Appln. No. 10/754,505
Amdt dated November 15, 2005
Reply to Office Action of August 19, 2005

Amendments to the Drawings

Fig. 2

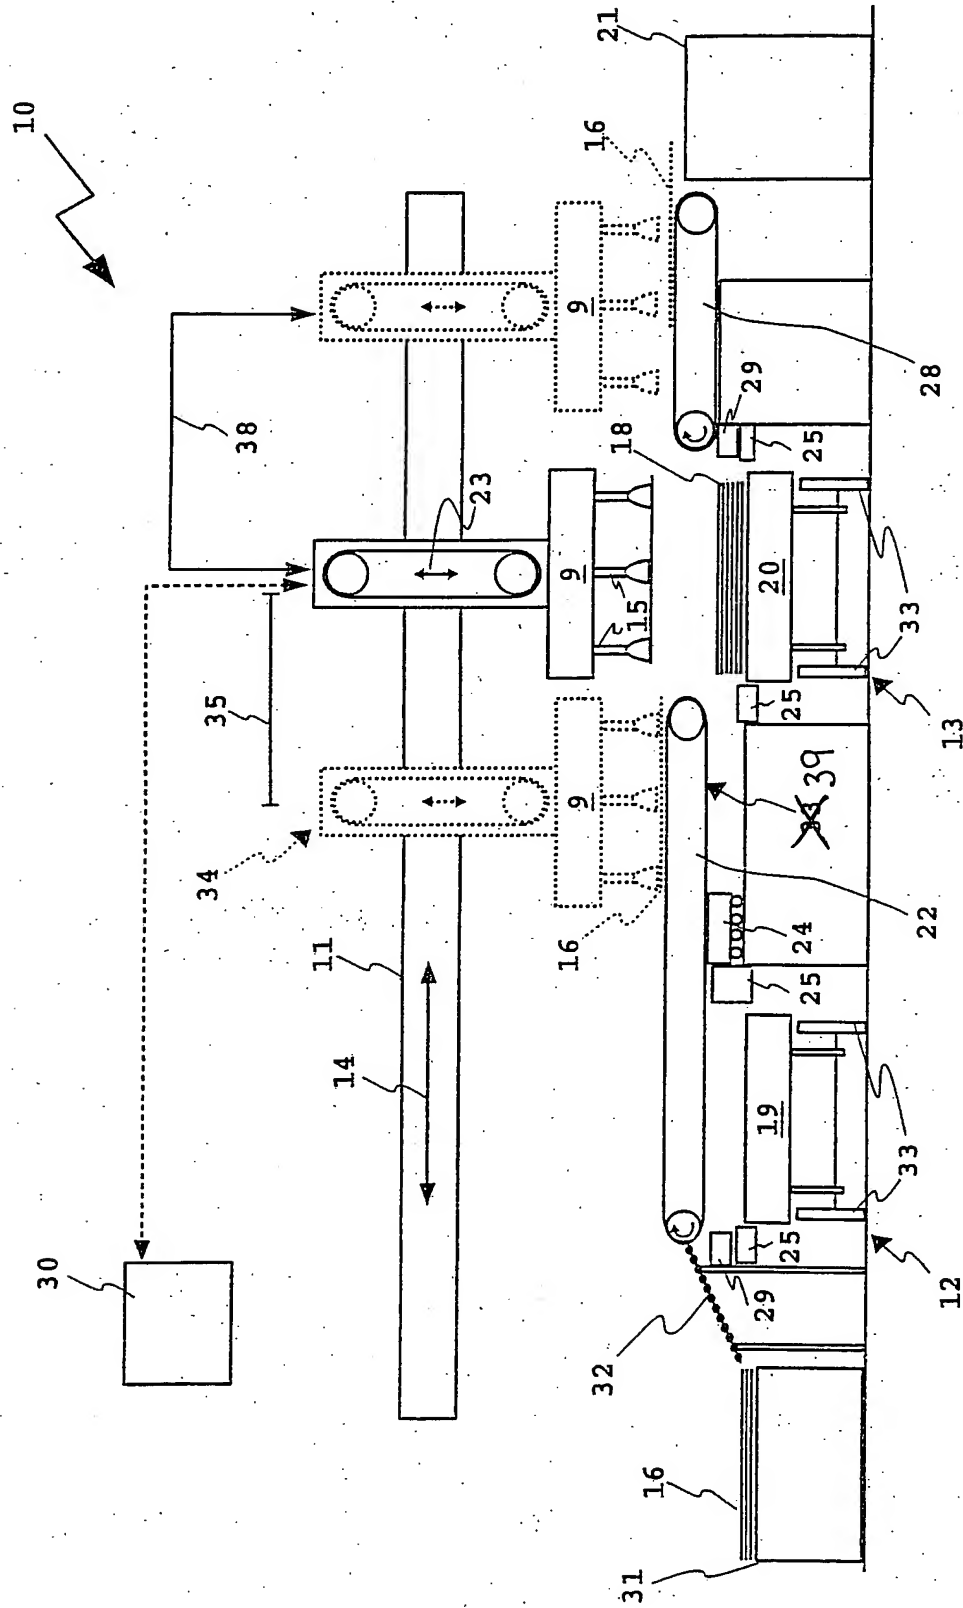
Applicant has, however, enclosed an amendment to Fig. 2, wherein the multiple use of numeral "33" has now been corrected by numbering the "second longitudinal position" as "39" rather than "33". Corresponding amendments have also been made on page 8 of the disclosure.

The attached sheet of drawings includes changes to Fig. 2. This sheet, which includes Fig. 2, replaces the original sheet including Fig. 2. In Fig. 2, the second longitudinal position "33" has been corrected to show "39".
